Meriden-Wallingford Cardiovascular Associates, LLC  
1062 Barnes Road Suite 300  
Wallingford CT 06492

Please amend our byproduct materials license number 06-30842-01 as follows:

# MERIDEN WALLINGFROD CARDIOVASCULAR ASSOCIATES, LLC ROOM DETAILS

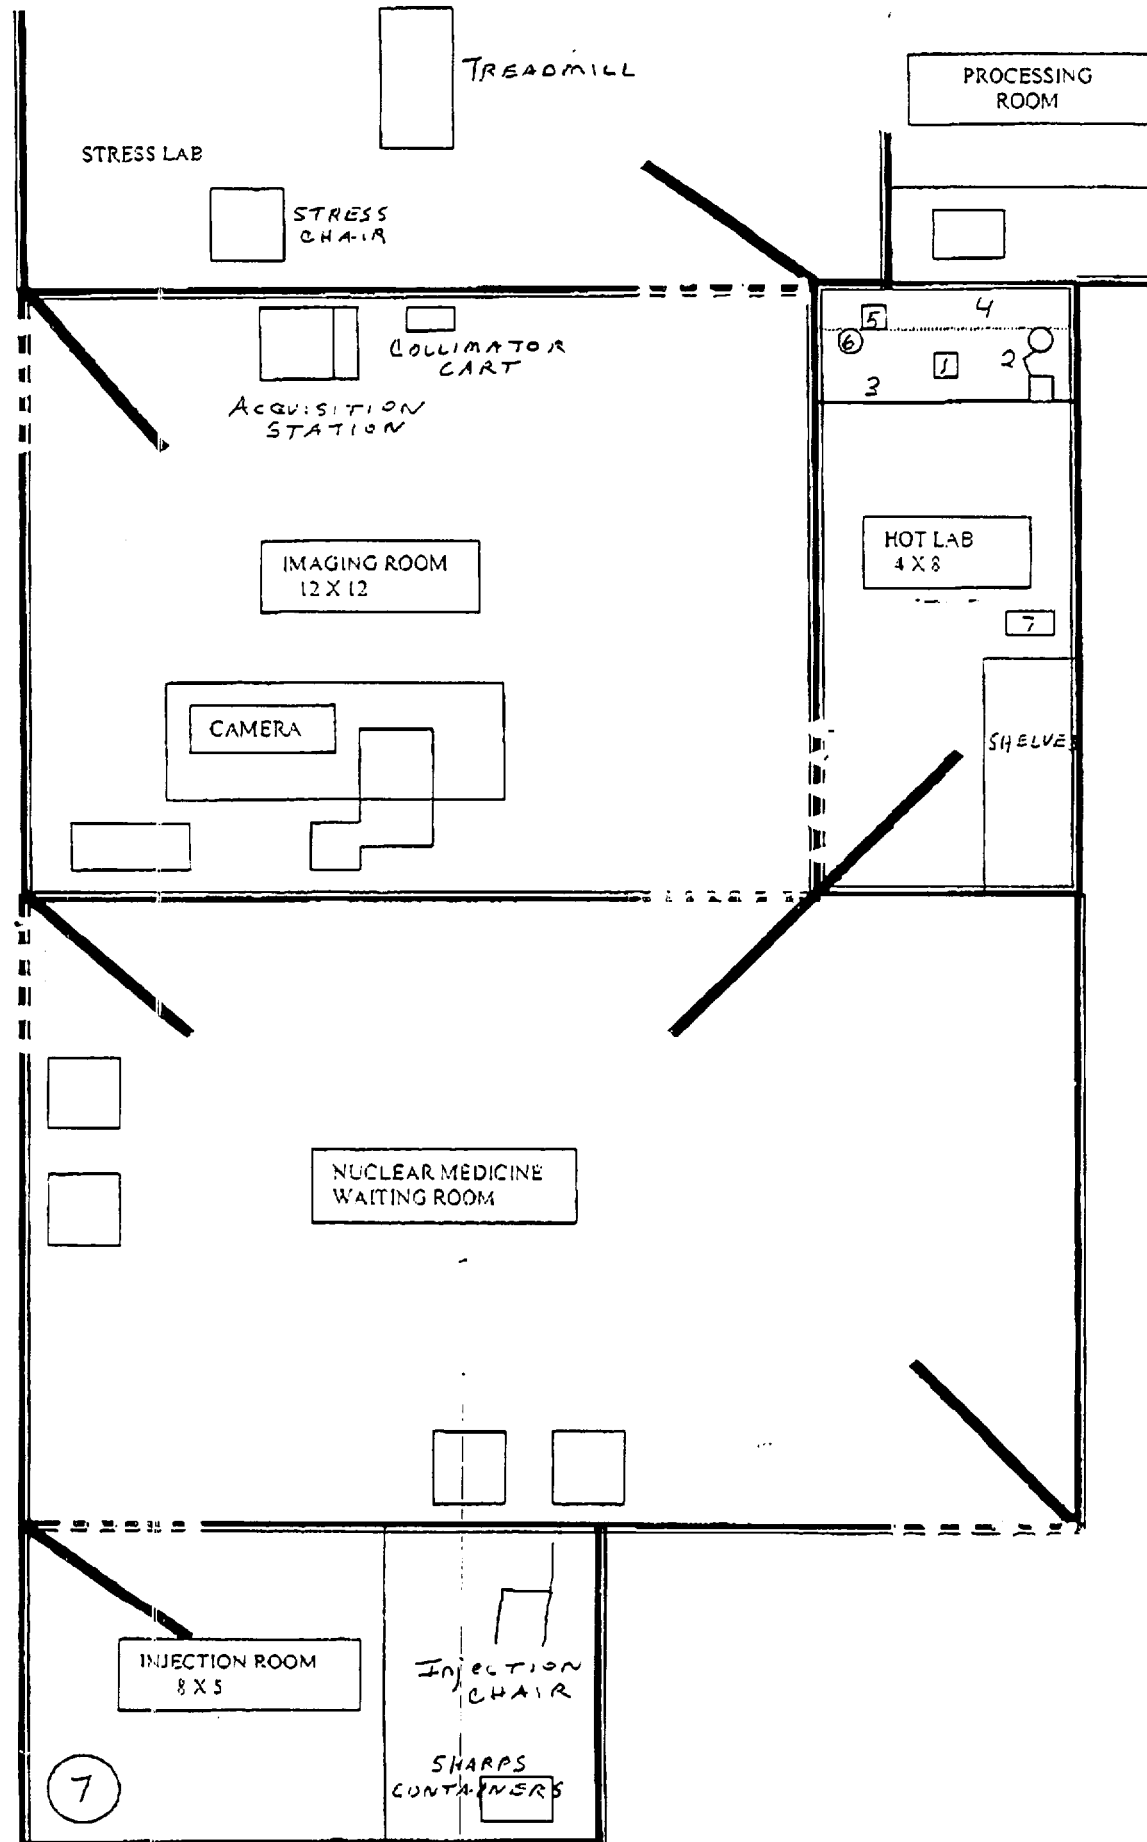
We have relocated our injection area as seen on the enclosed Room Detail sketch. We will include this in our daily area surveys and weekly wipe testing as stated in our earlier license commitment.
